Monira Knit Apparels Ltd. Colour Fashion Ltd.

191, West Masdair, Fatullah, Narayanganj-1400
(23.628361N, 90.485250E)

12 April 2014

Flexural Cracking in Floor Slab Soffits

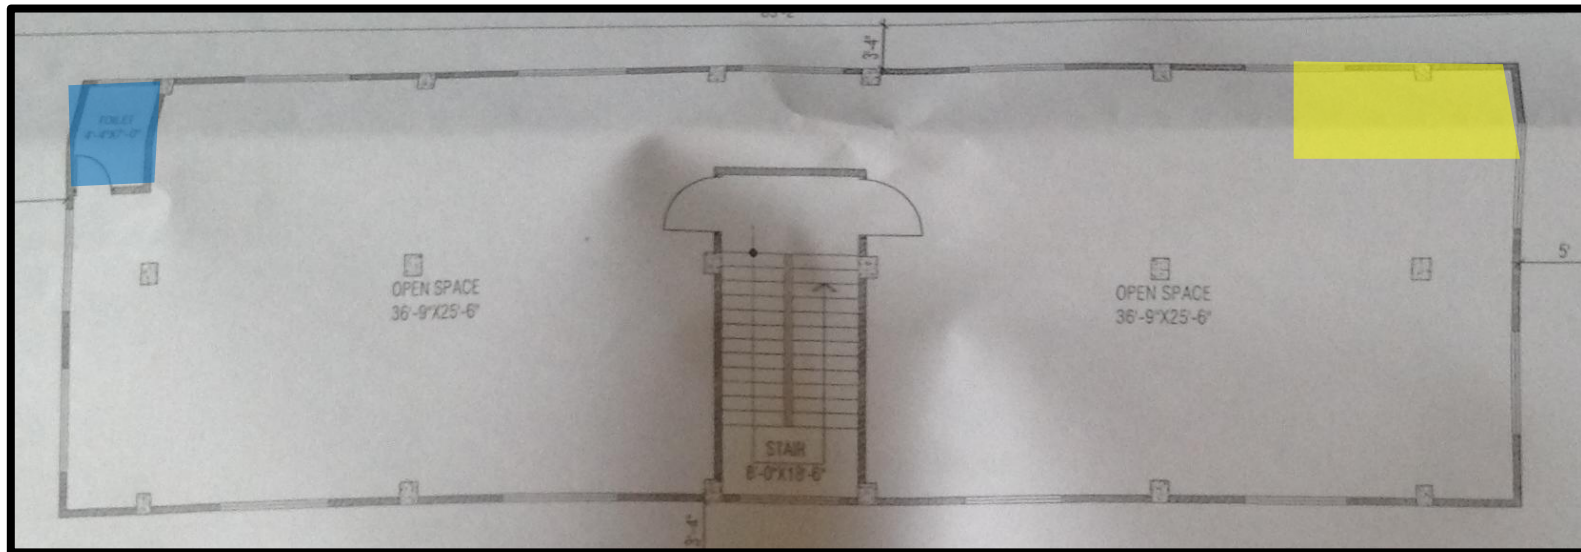
Flexural cracking was observed in flat slab soffit at most levels.

Item No.	Observation	Recommended Action Plan	Recommended Timeline
8	Flexural cracking in floor slab soffits	Engage an Engineer to investigate if the cracking is structural or exists only in the render, as part of the Detailed Engineering Assessment noted in item 1.	6-weeks
9	Flexural cracking in floor slab soffits	Engineer is to undertake checks for flexural and punching shear capacity.	6-weeks
10	Flexural cracking in floor slab soffits	Carry out any remedial work as directed by the Engineer.	6-months
11	High loading in toilet areas on cantilevers	Engage an Engineer to investigate if the applied loading can be safely carried by the slabs and by the columns, as part of the Detailed Engineering Assessment as noted in item 1.	6-weeks
12	High loading in toilet areas on cantilevers	Carry out load reduction and/or any remedial work as directed by the Engineer.	6-months

Toilets at Levels 1 & 6

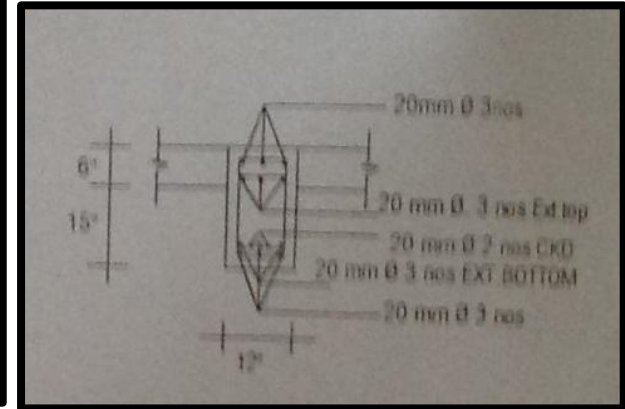
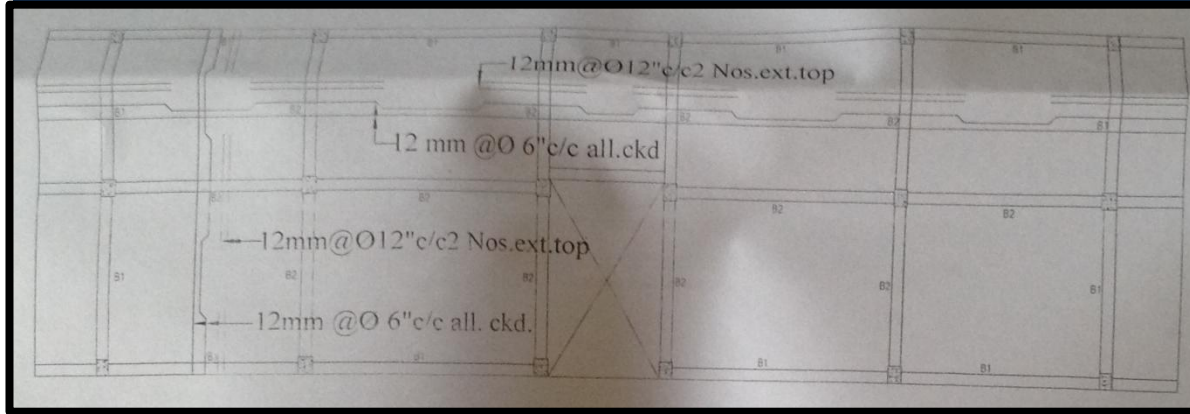
High loading was observed on cantilevers, especially in toilet areas with floor build-up.
